JM Fabrics Ltd. (Extension 2)

05 and 30 March 2026

2. Observations

Observation-8: Lack of design report. (External steel stair, Building 8)

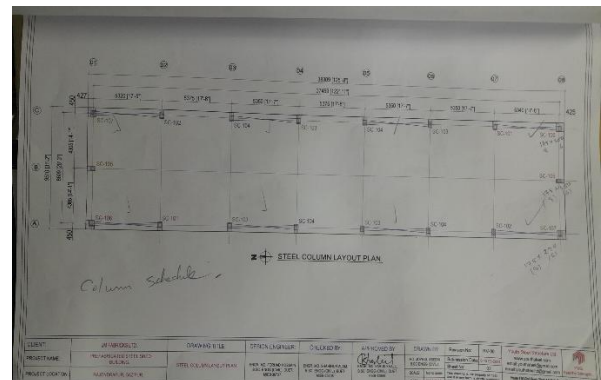
Description: As per BNBC, every building or structure designed shall have its design documents prepared following the provision of Section 1.9.1. The design document shall include a design report and a structural drawing. At the time of inspection, no design report was available which is required to be prepared (including roof shed) in compliance with section 1.9.1.1 and section 1.9.1.2 (part 6, BNBC).

22.	Lack of design report. (External steel stair, Building 8)	The building engineer is required to prepare design report following BNBC 2020 and submit it to RSC for detailed review.	within 6 weeks
